**PSE Autoclass SD**  
**(New Figure, 33.2.5.12)**

**PD Autoclass SD**  
(Modify Figure, 33.3.3.11)

**PSE DLL Autoclass Control SD**  
**(Replace Figure 33-47, 33.5.3.6)**

**PD DLL Autoclass Control SD**  
**(Replace Figure 33-48, 33.5.3.6)**

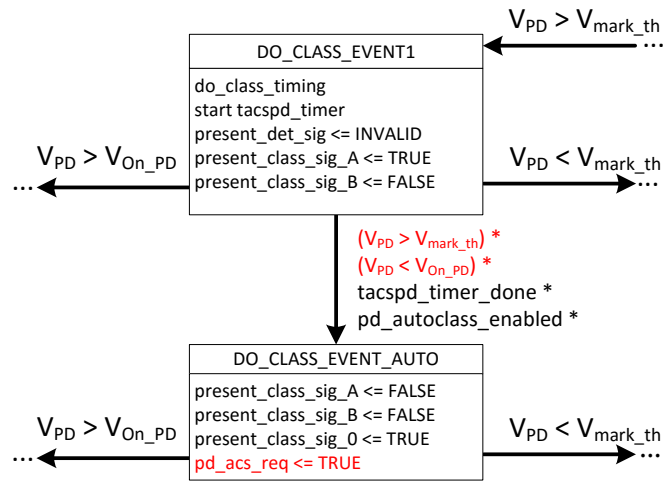
**Define new variable (33.2.5.9):**

MirroredPDAutoclassRequest

A control variable output by the PSE power control state diagram that indicates whether the PSE has received an Autoclass measurement request from the PD via the Data Link Layer. See 33.5.

**Define new timer (33.2.5.10):**

tauto\_pse1\_timer

A timer used to delay Autoclass power measurement following transition into state POWER\_ON; see  $T_{\text{AUTO\_PSE1}}$  in 33.2.7.3.

tauto\_pse2\_timer

A timer used to limit Autoclass power measurement following transition into state POWER\_ON; see  $T_{\text{AUTO\_PSE2}}$  in 33.2.7.3.

**PD Autoclass SD**  
(New Figure, 33.3.3.11)

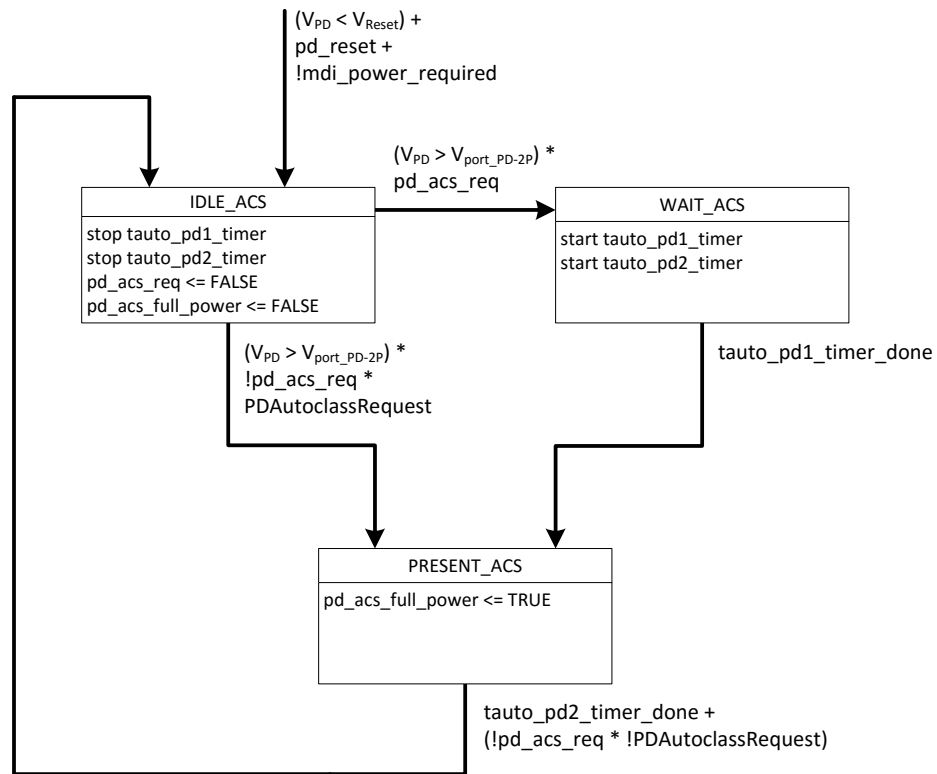
**Define new variables (33.3.3.8):**

pd\_acs\_req

This variable indicates whether the PD performs an Autoclass request during Physical Layer classification. See 33.3.6.3.

pd\_acs\_full\_power

This variable indicates whether the PD is required to draw maximum power,  $P_{\text{Autoclass\_PD}}$ . See 33.3.6.3.

PDAutoclassRequest

A control variable output by the PD power control state diagram indicating whether the PD requests Autoclass via the Data Link Layer. See 33.5.

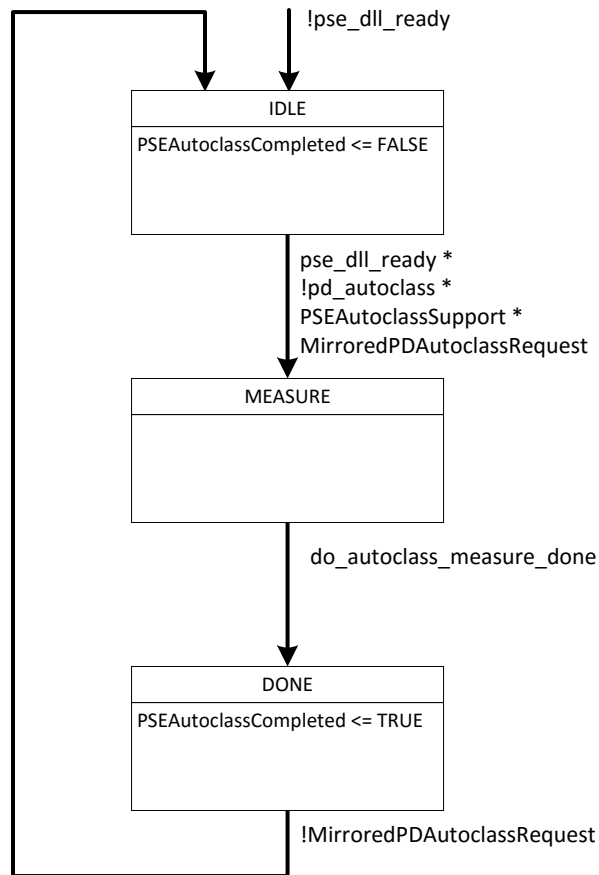
**Define new variable (33.2.5.9):**

pd\_autoclass

A control variable output by the Type 3 and Type 4 PSE state diagram indicating whether the PSE has observed an Autoclass measurement request during Physical Classification. See 33.2.5.9.
